## Technical change to Board-to-Board connectors

the products of our OMNIMATE® Board-to-Board connectors will be changed after a transitional period.  
Please pass on this Product Change Notification (PCN) to your employees and, if applicable, to your customers.

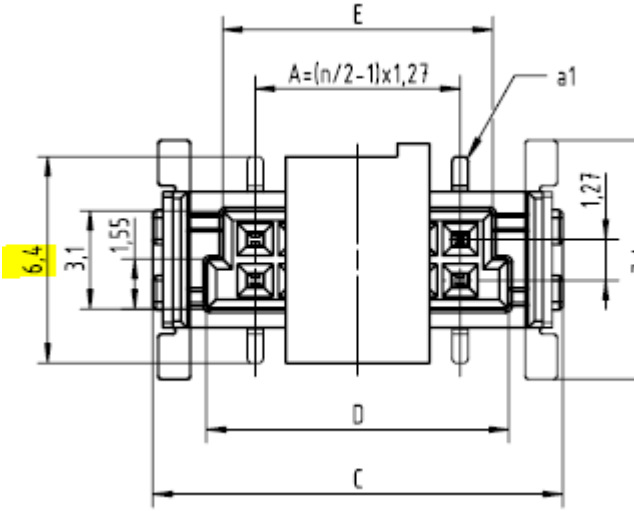
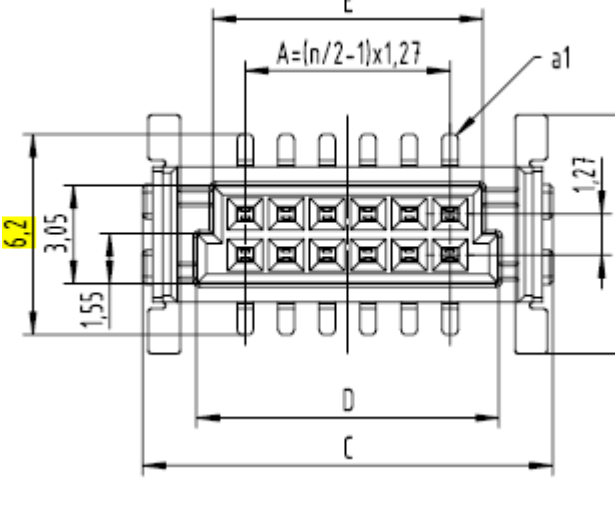
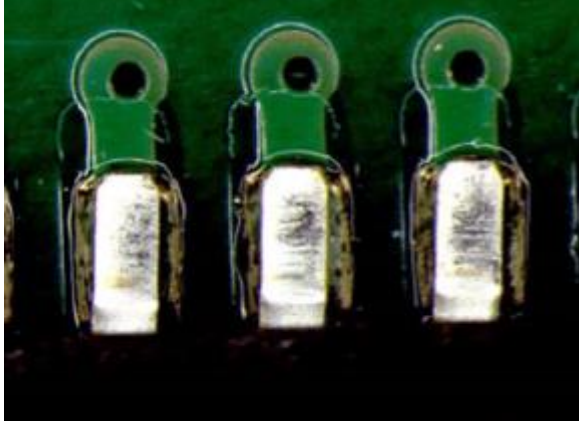
To enhance the automatic optical inspection process for our customers, we will be reducing the length of our solder pins. In the past, there were instances where the contact points protruded slightly, but this change will prevent such occurrences in the future. Moreover, the new dimensions will facilitate more clearly identifiable solder joints and the corresponding meniscus, resulting in improved controllability during the PCB assembly process.

Furthermore, we are planning to replace the pick-and-place pads for connectors with 12 or more pins. The larger pads will accommodate the use of larger standard nozzles, thereby increasing placement speeds.

Old design	New design

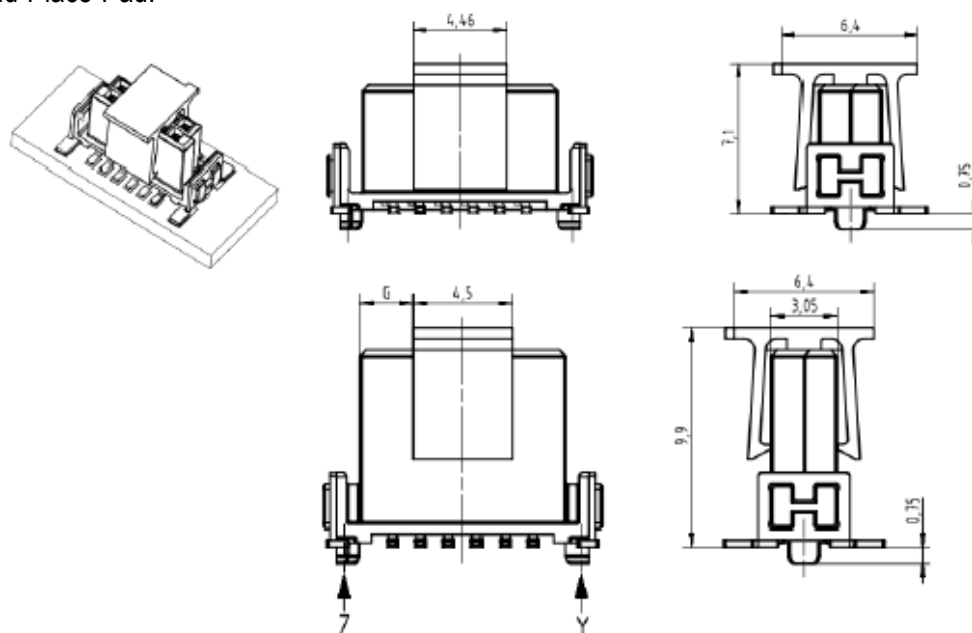
The measurement of the solder pins will be adjusted from 6.4mm to 6.2mm, with a tolerance of +/- 0.2mm. This change will enable a target solder meniscus of 0.2mm.

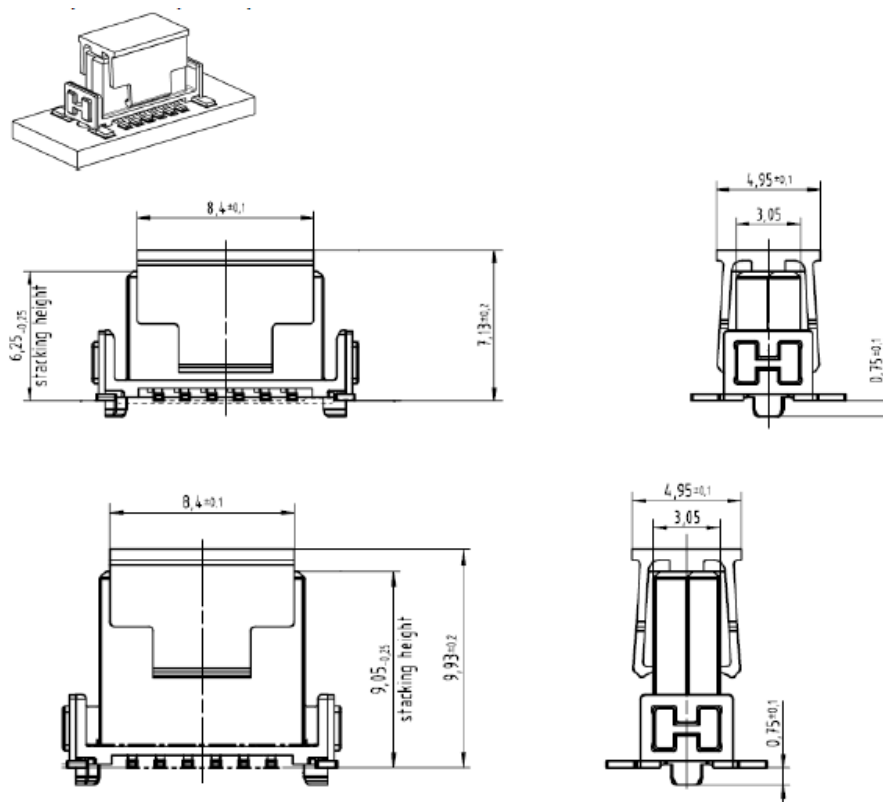
Furthermore, we will be upgrading the pick-and-place pads for the mentioned connectors that have 12 or more pins. These larger pads will allow for the utilization of standard nozzles with larger diameters, resulting in increased placement speeds.

Old Pick-and-Place-Pad:

New Pick-and-Place-Pad:
